MEMORANDUM

SUBJECT: SF-19-009– Retreat at Timber Ridge Filing 1  
Second Submittal

RETREAT AT TIMBERRIDGE FILING NO. 1  
CONSTRUCTION DRAWINGS  
TITLE SHEET

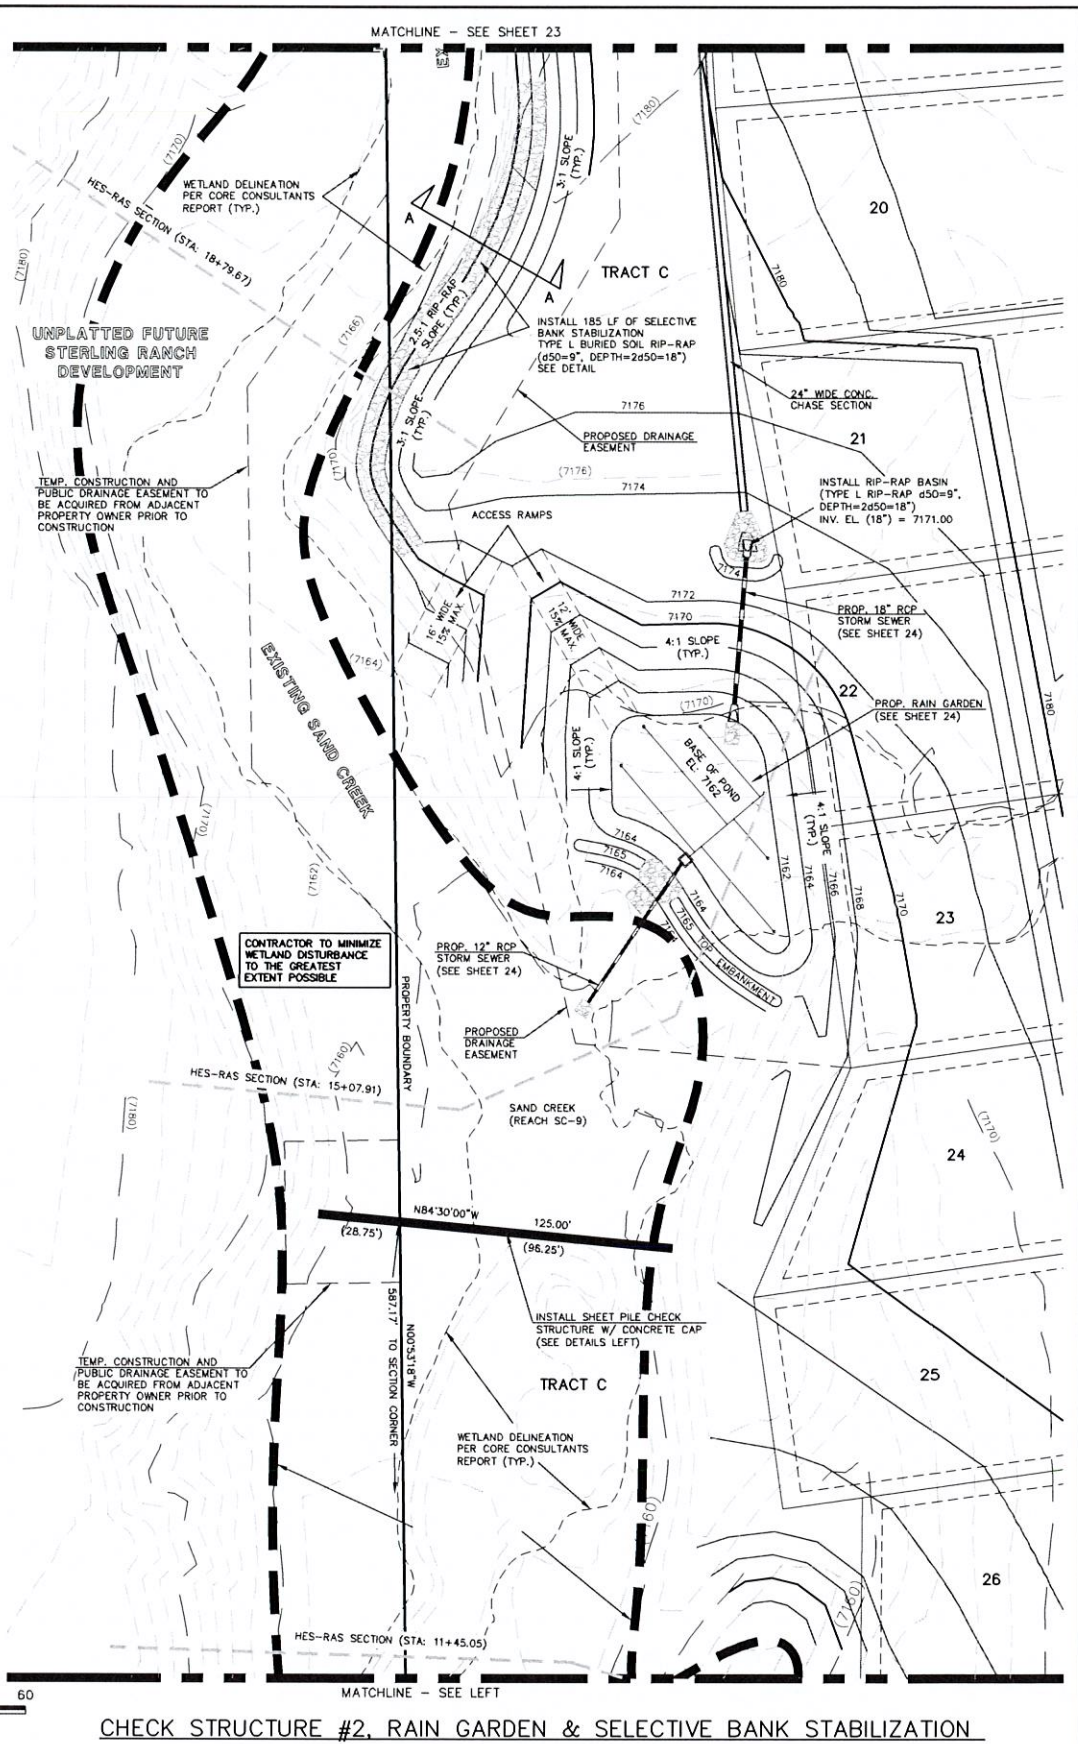
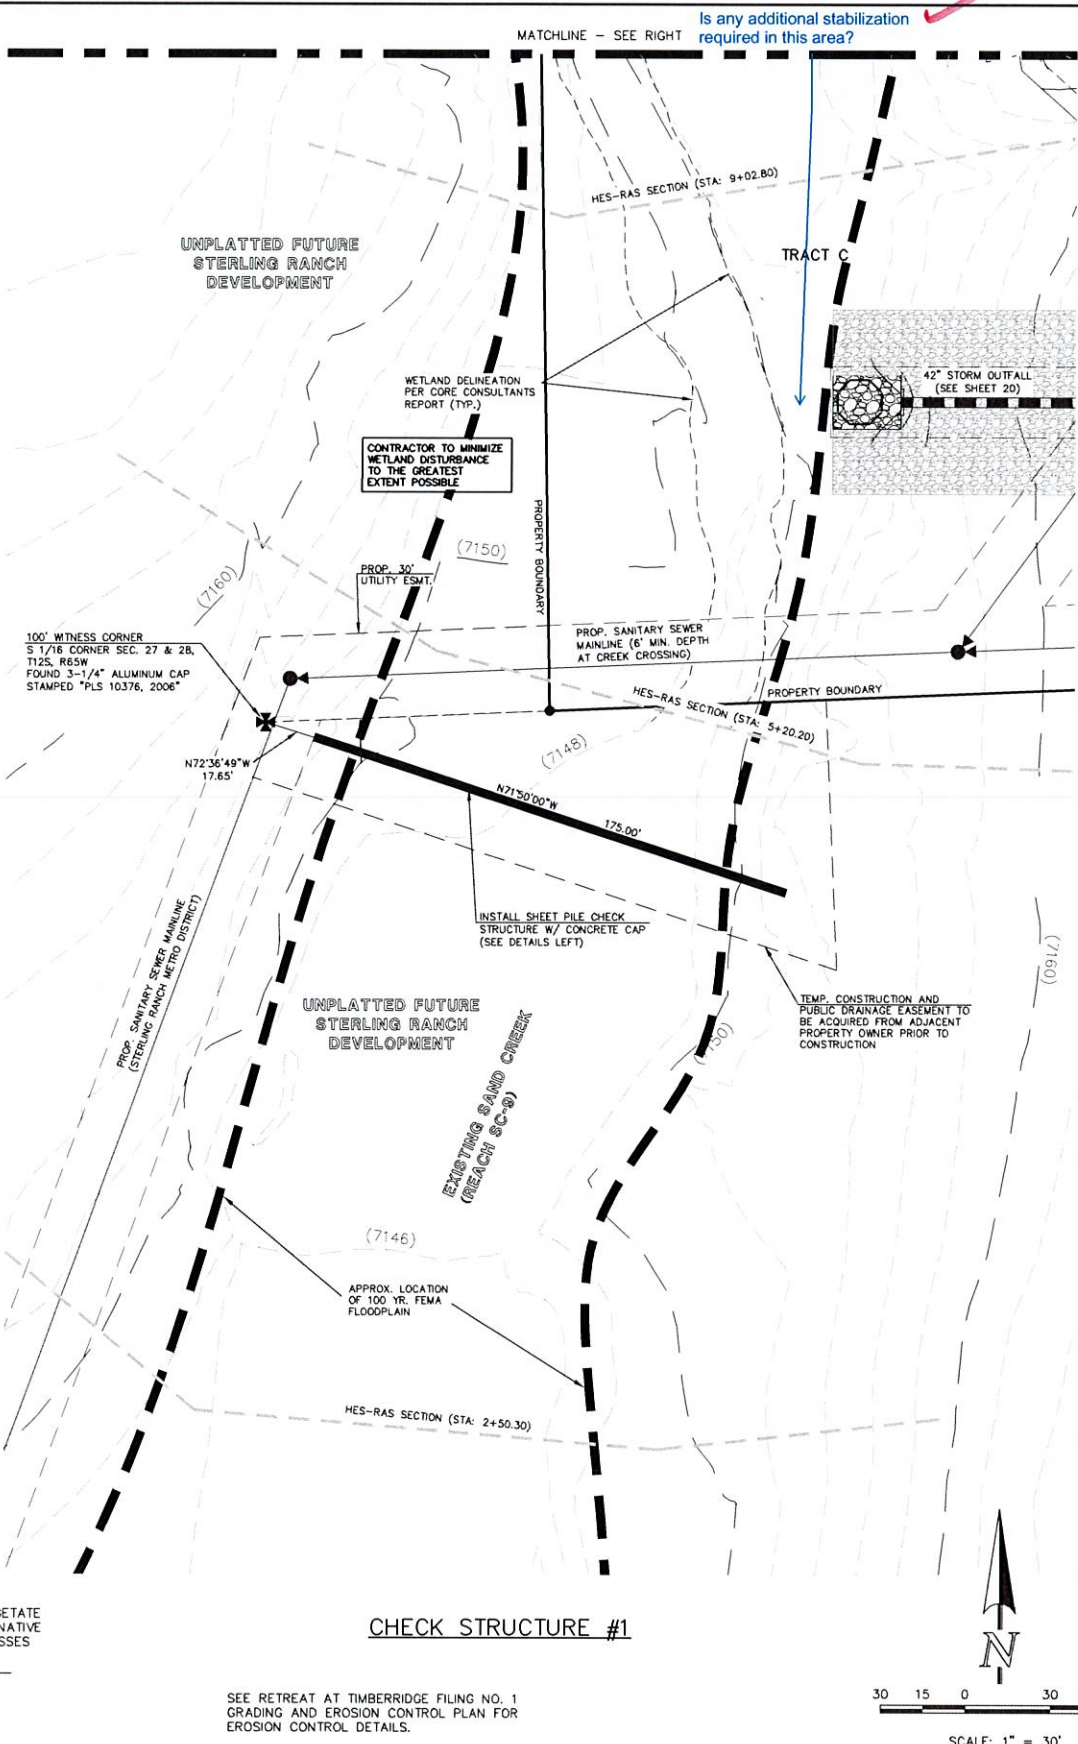
See comment letter regarding proposed culvert material.

*See Final Design plans from comtech*

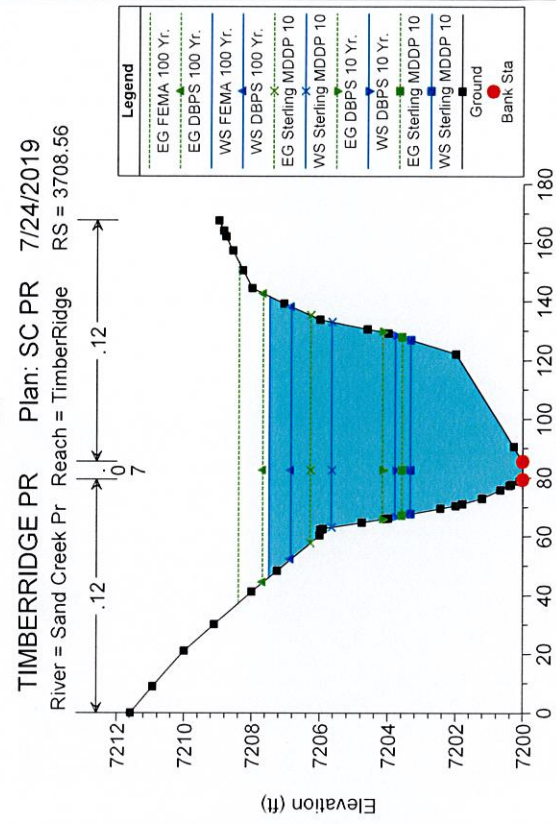
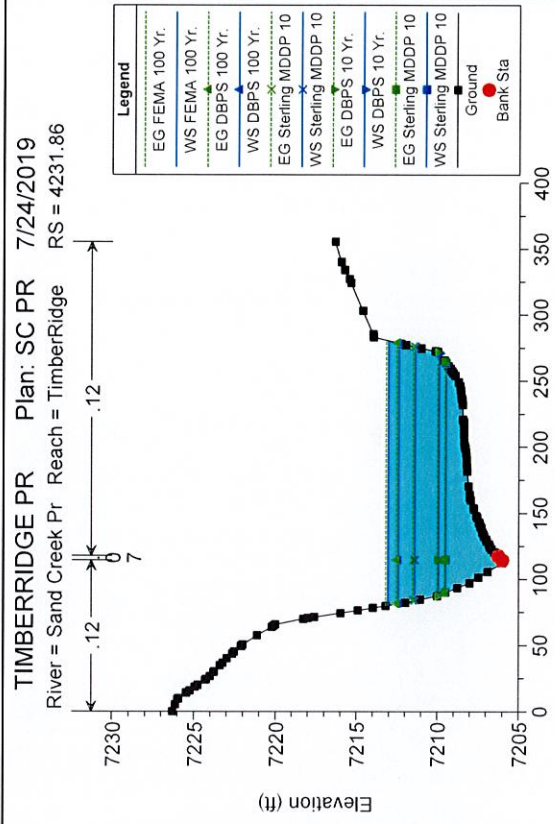
protect bend, side slopes
